TECHNICAL BULLETIN

MODEL/DERIVATIVE:
MINI

Bull. N°: 0031
CDS. ref: R7532bu
Issue: 1
Date: 19.11.97

PROBLEM:
SEAT CUSHION DAMAGED - UNRESTRAINED TIPPING

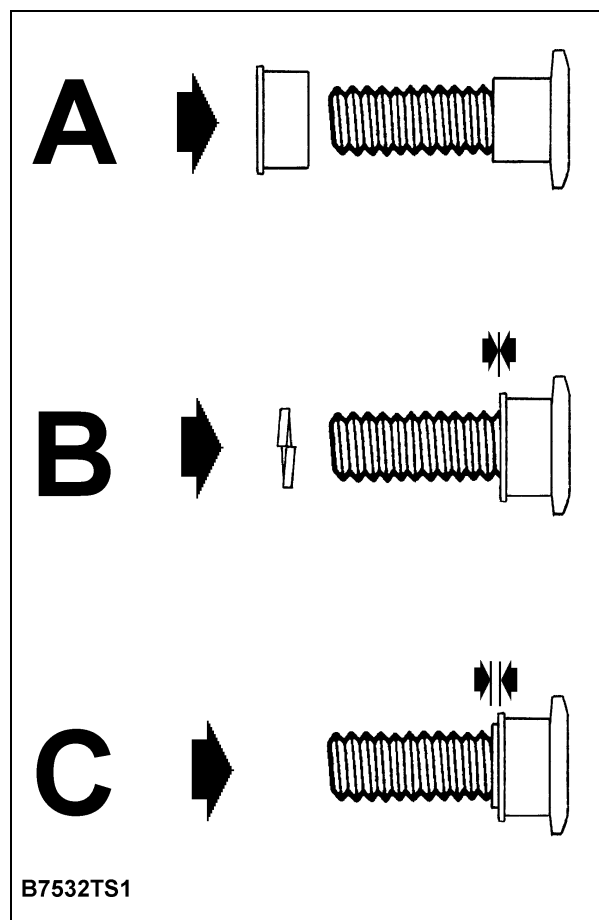
1. Carefully disengage the rear escutcheon fixing from one seat side to expose hinge.
Note: try not to bend escutcheon excessively as this may break plastic fixings or bruise the outer escutcheon surface.
2. Remove the black Torx 50 squab striker and plastic sleeve. If a flat washer is also fitted retain this for re-fitment.
3. Reverse the sleeve position on striker so that sleeve flange is now adjacent to thread (illustration 'A').

4. View sleeve end in relation to striker shoulder. If flush with shoulder (illustration B), fit a suitable size spring washer to provide a shoulder extension, 'see parts information'. If shoulder protrudes slightly (illustration 'C'), no spring washer is required.
5. Fit check strap by hooking tab into redundant hole position in hinge (see photo inset).
6. Re-fit and tighten striker bolt so that the exposed striker shoulder or spring washer locates check strap slot. If a flat washer was originally fitted, refit between check strap and seat frame.
7. Re-fit escutcheon rear fixing.
8. Repeat modification for opposite side of seat.
9. Ensure that squab tips satisfactorily and that seat locks securely in upright position.
